File In Section: Product Recalls
Bulletin No.: 08048C
Date: April 2009

PRODUCT SAFETY RECALL

SUBJECT: Heated Windshield Washer Module Short Circuit – Add Wire Harness

The service procedure in this bulletin has been revised to include verification that the fluid system dispenses heated fluid. Please discard all copies of bulletin 08048B, issued October 2008.

Jumper Harness with In-Line Fuse

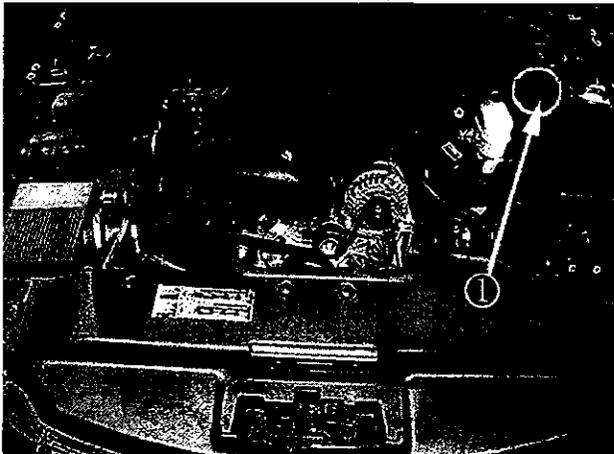
Dealers/retailers are to install a wire harness with an in-line fuse.

Part Number	Description	Quantity/Vehicle
20773432	Harness, WSW Wrg Harn Extn	1

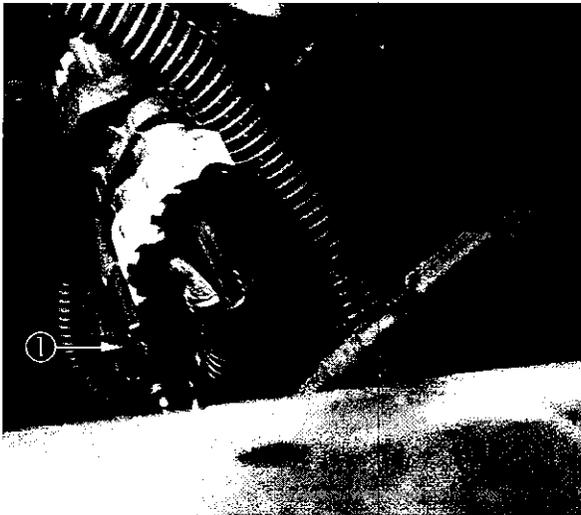
3. Connect the jumper harness with the in-line fuse (1) to the windshield solvent heater module wire harness (2) as shown in the illustration.
